**STAFF REPORT
KETCHUM PLANNING AND ZONING COMMISSION
REGULAR MEETING OF FEBRUARY 11, 2025**

PROJECT: Sawtooth Serenade

FILE NUMBER: P24-027

APPLICATION: Final Design Review

DESIGN REVIEW SUBMITTAL

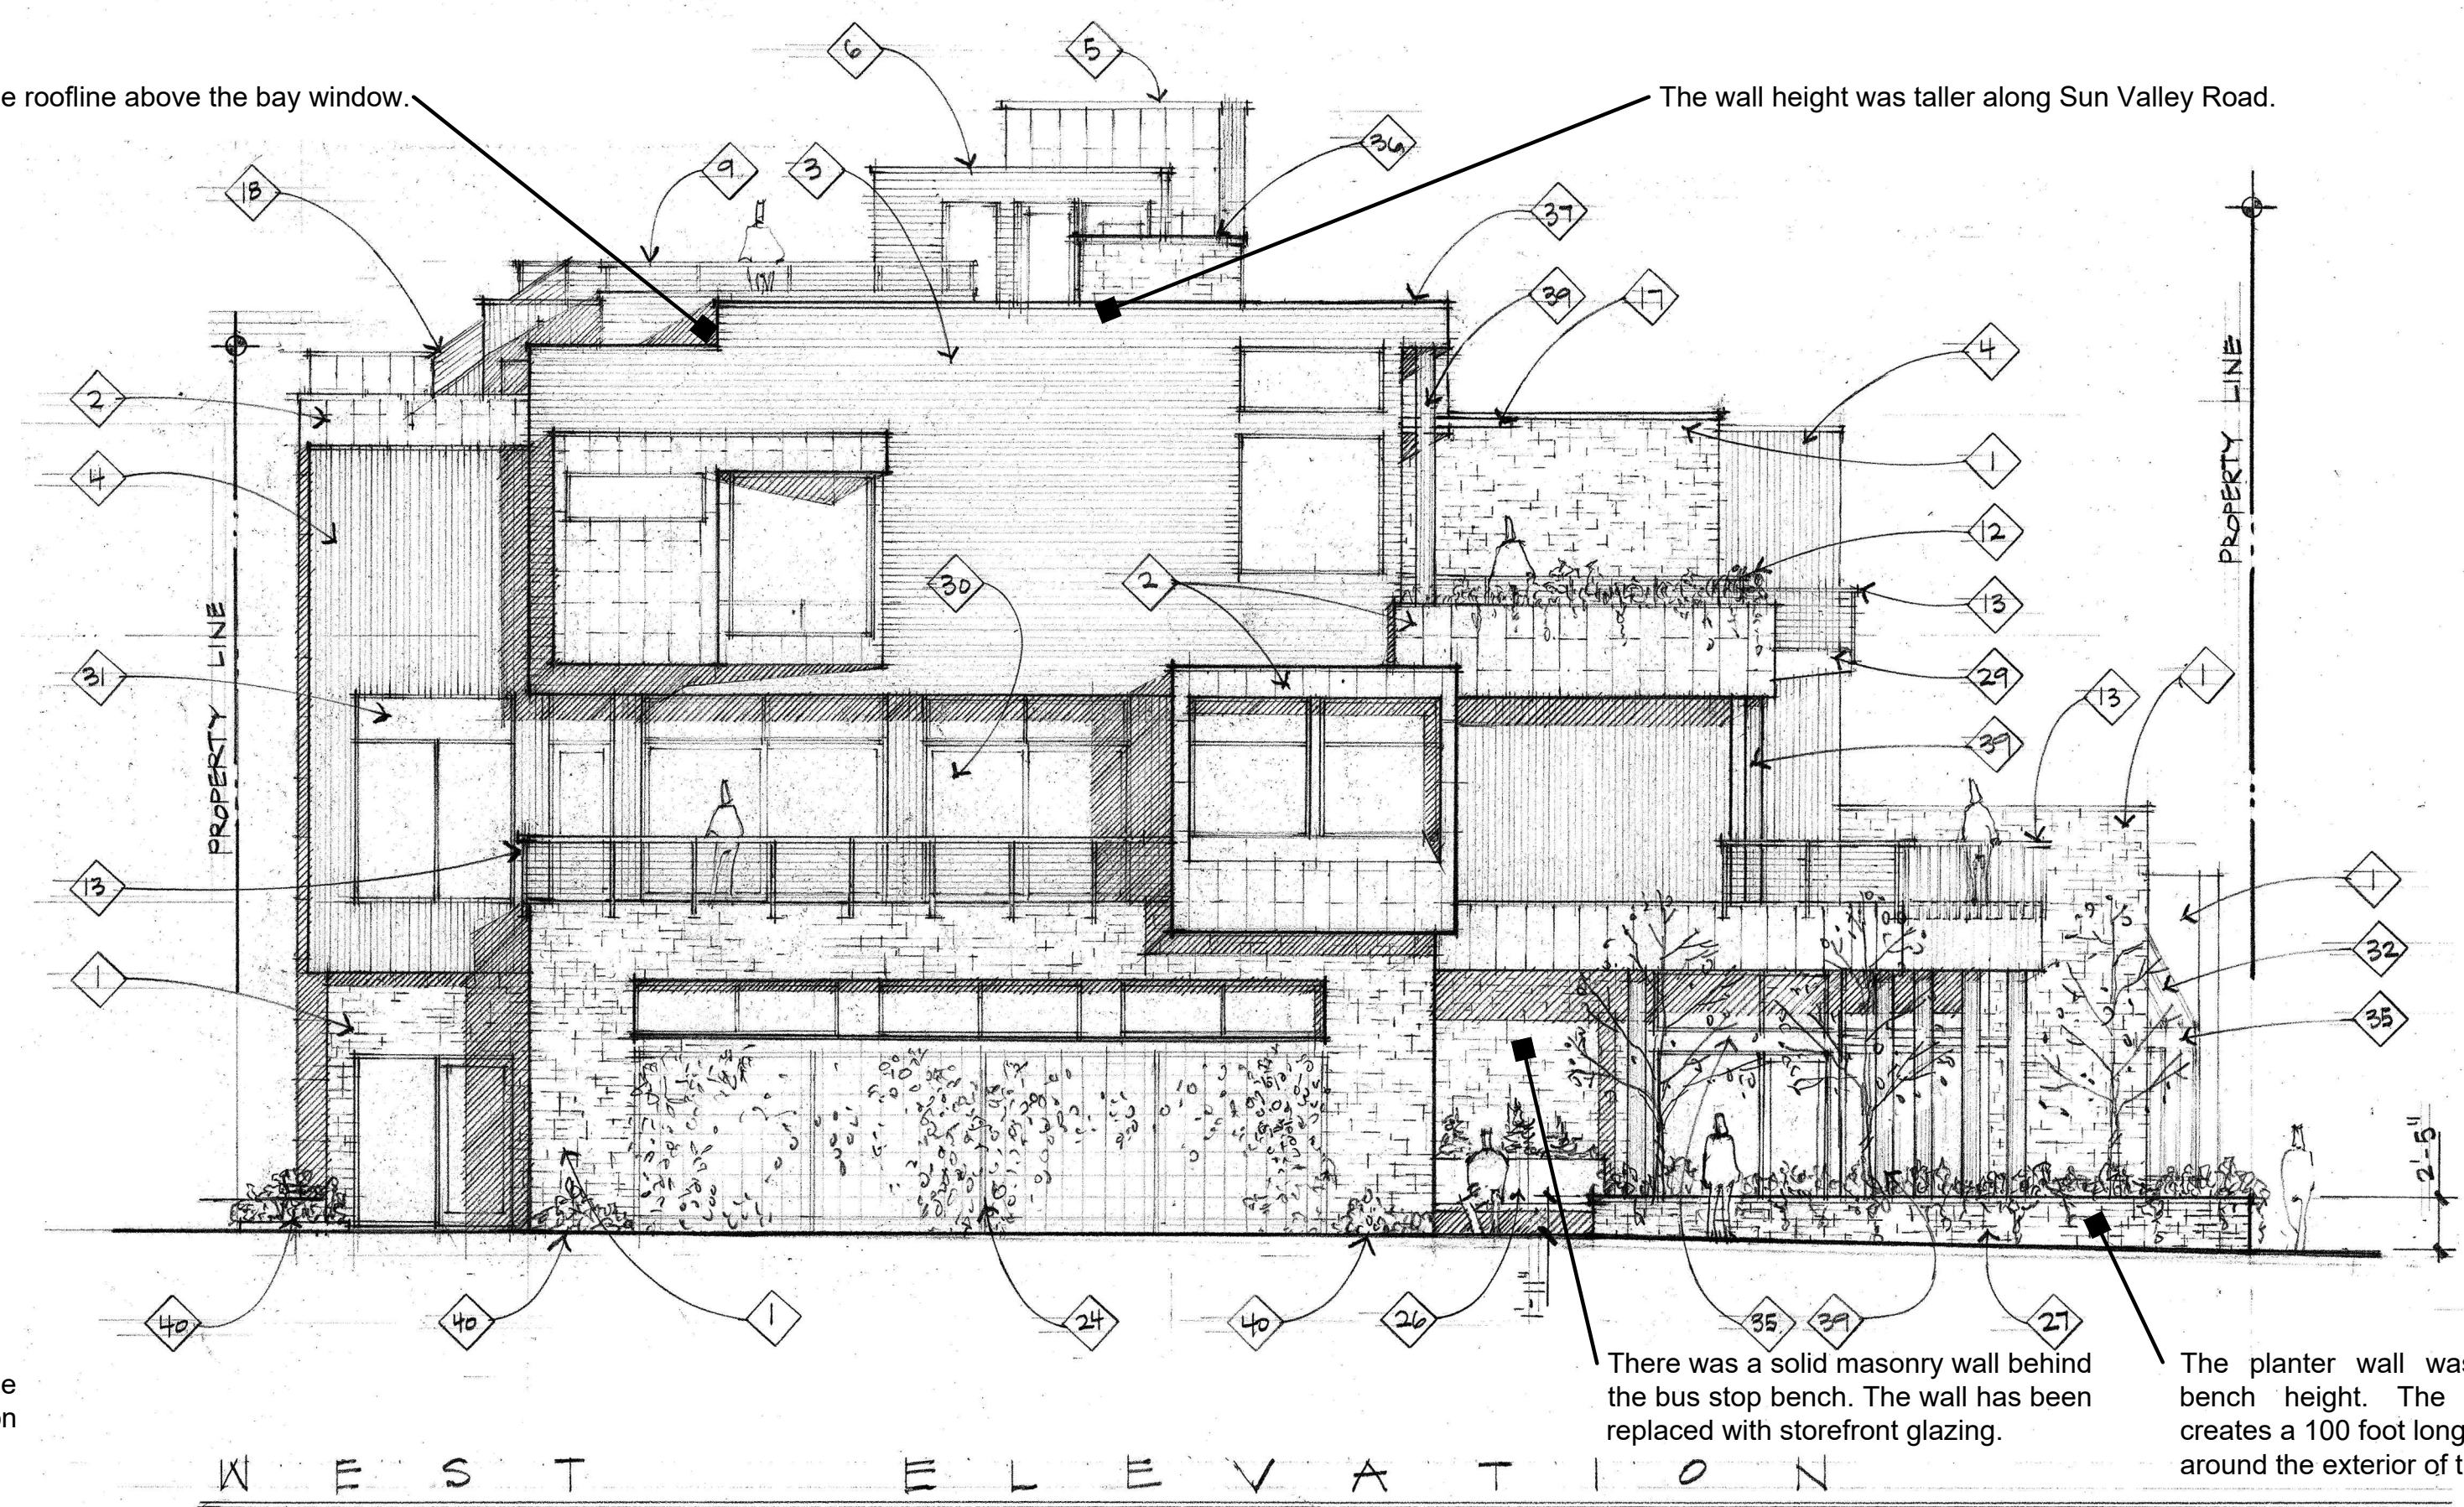
That's a closed-off area on a really activated corner - Commission Chair Neil Morrow

The storefront windows and doors on the lower floor were expanded to provide a stronger visual relationship between the Commons and the pedestrians on the street. The glazed area on the west elevation was increased by 117 sf.

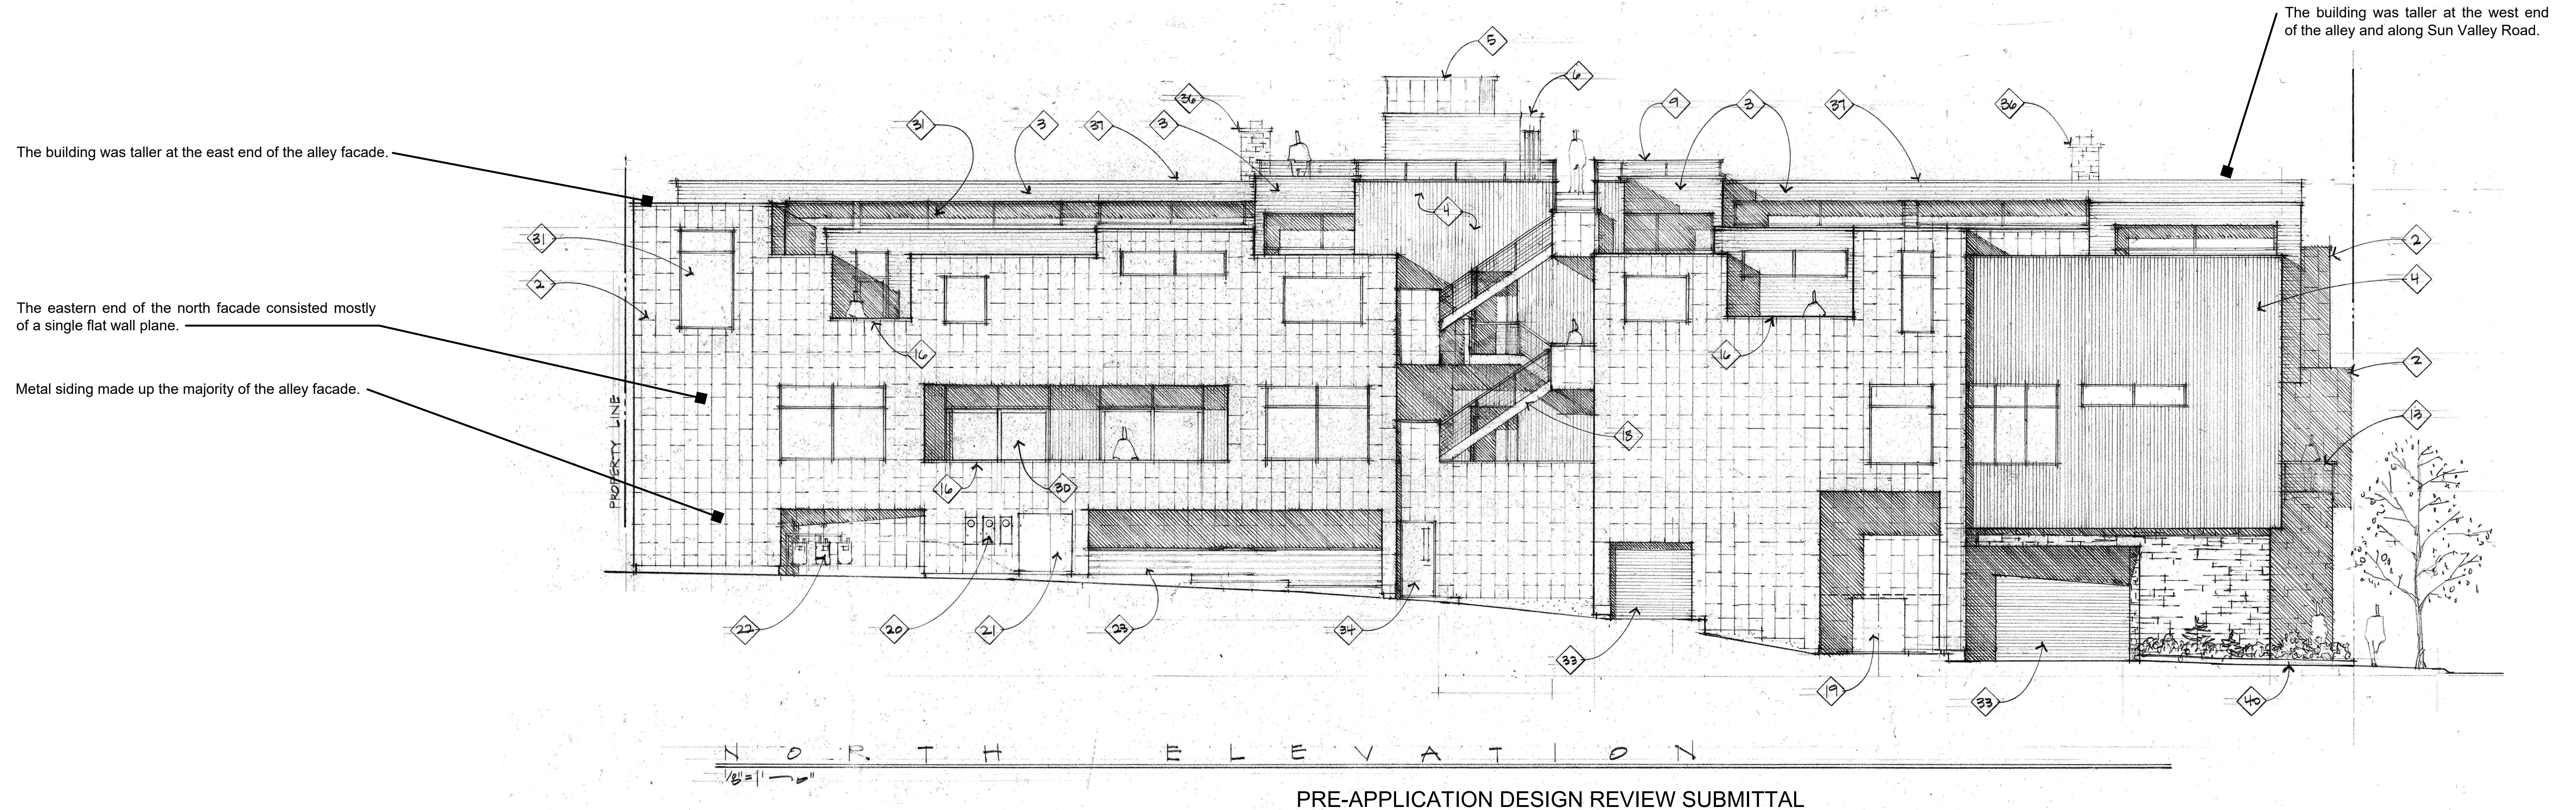
The metal paneling is continuing for the majority of the alley elevation...
It's a lot of black. - Commission Vice Chair Brenda Moczygemba

The percentage of metal siding on the north elevation has been reduced from 52% to 25% while the percentage of wood siding has been increased from 26% to 51% of the total area.

EAST ELEVATION - DESIGN REVIEW SUBMITTAL

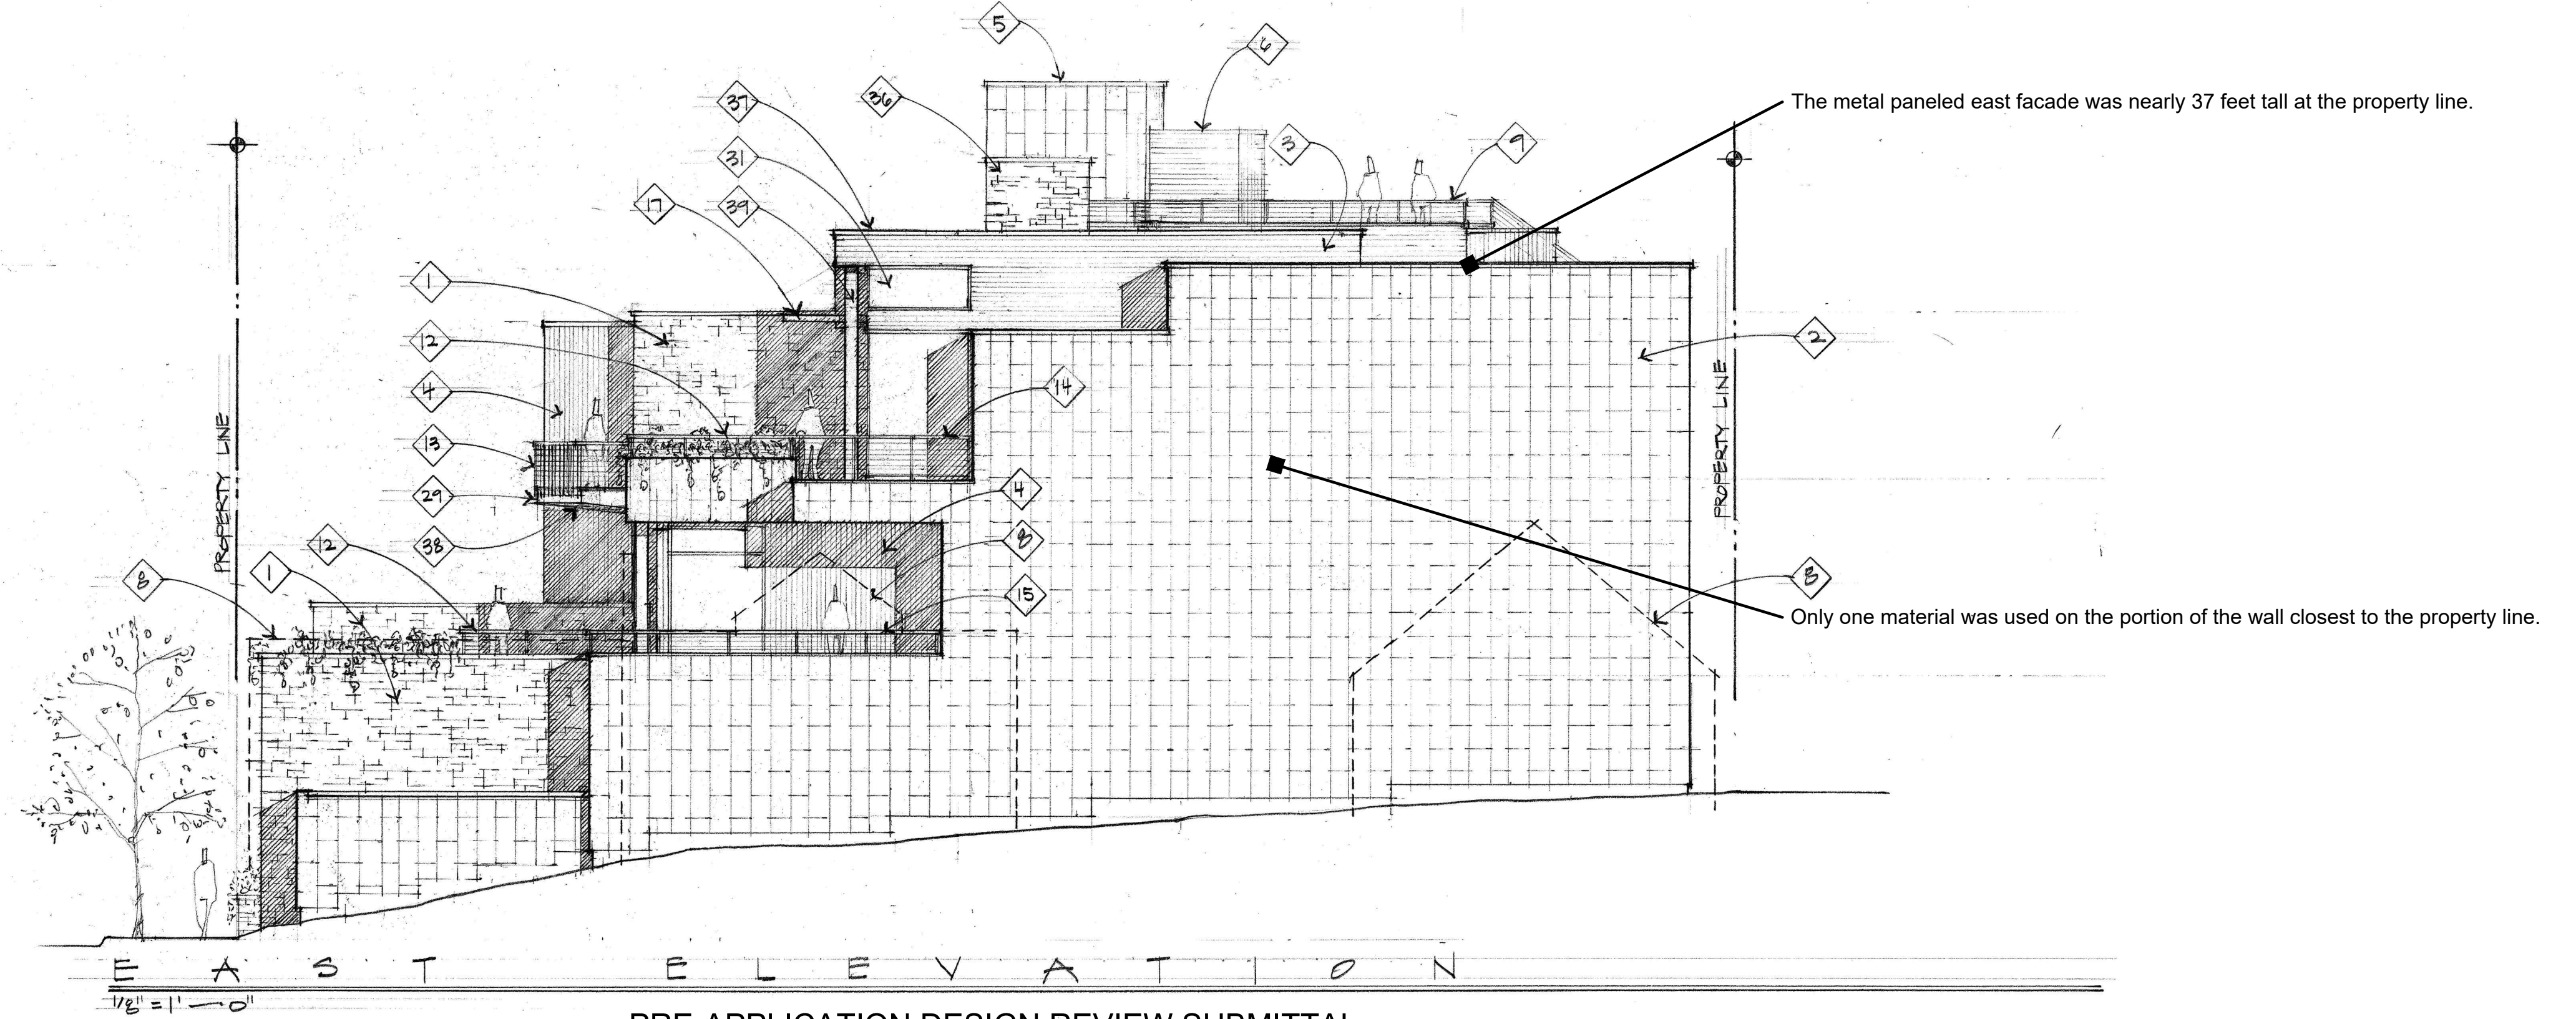
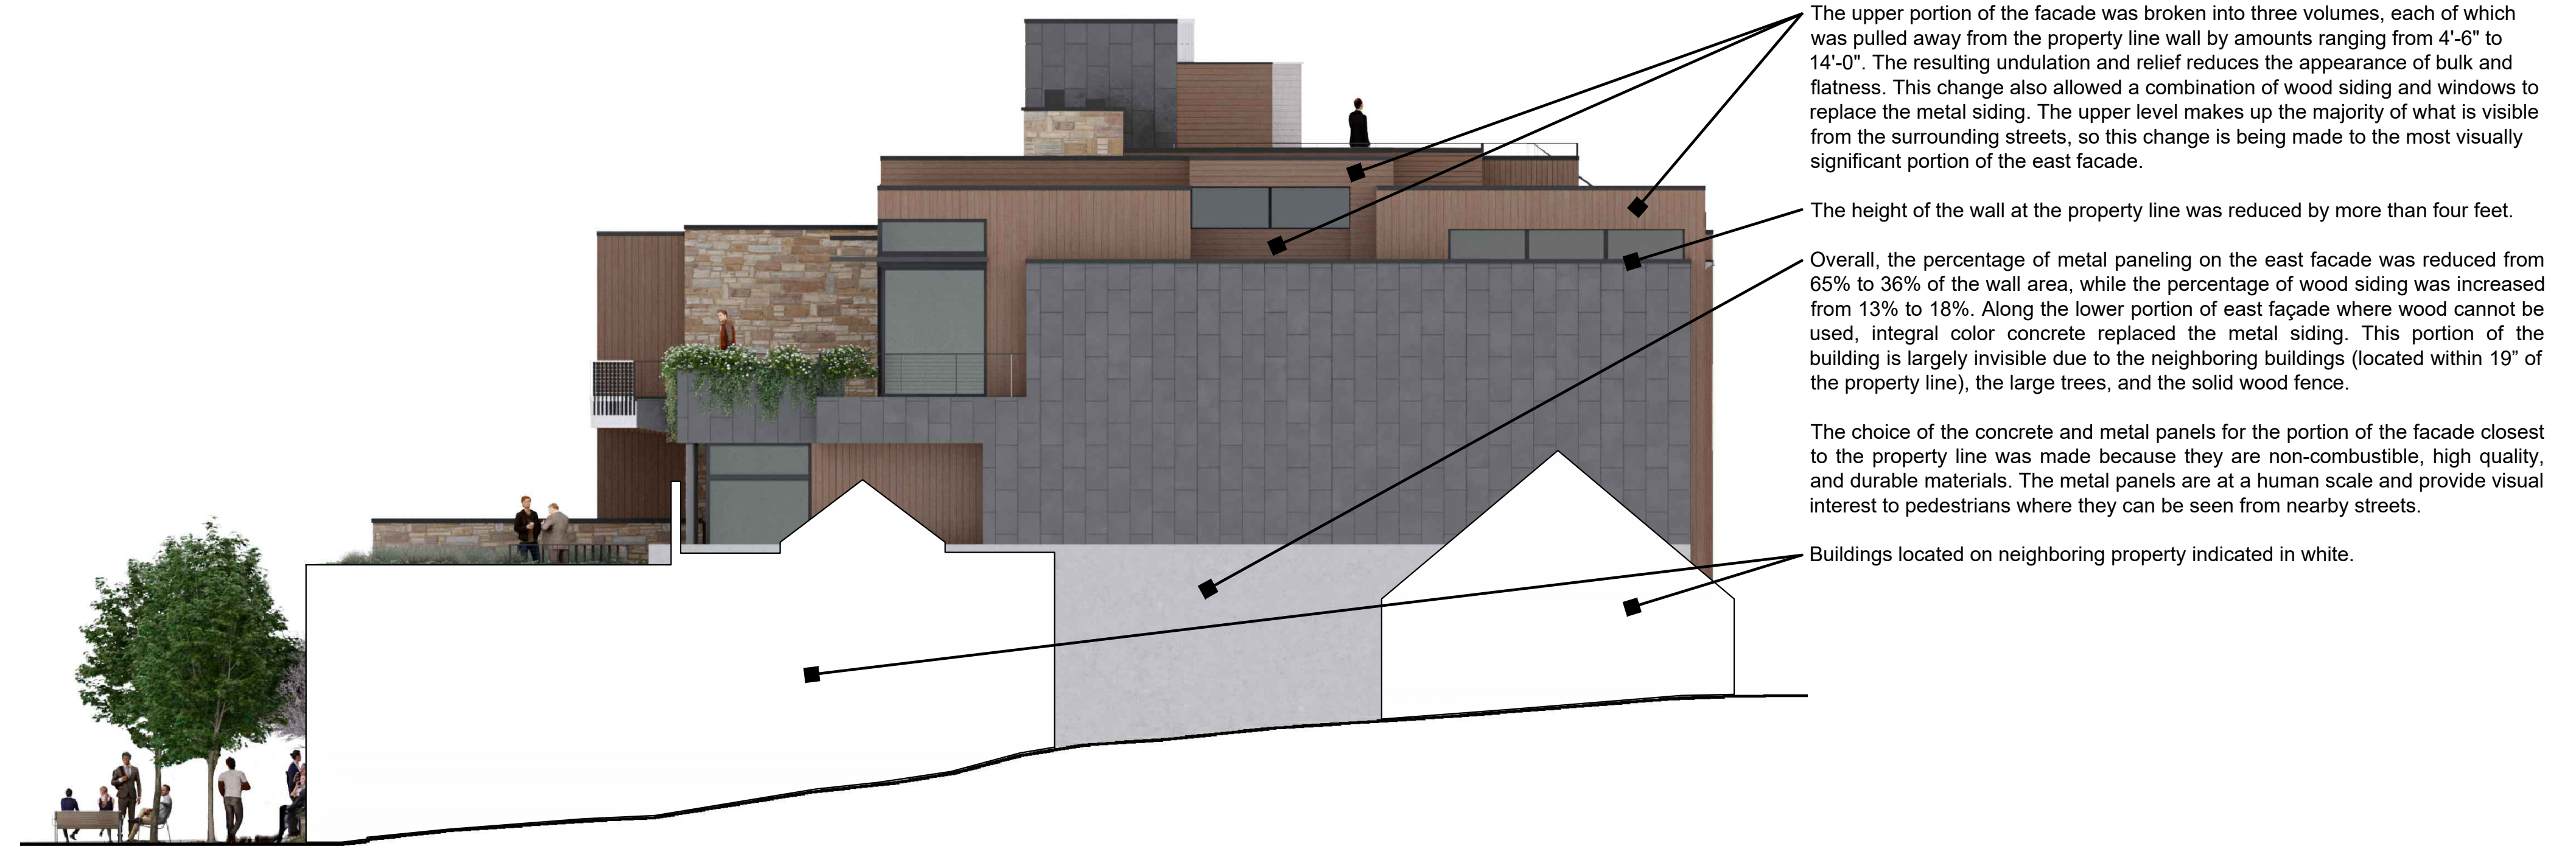
Overall, I don't think the mass of the wall on the interior property line is overbearing. - Commission Vice Chair Brenda Moczygemba
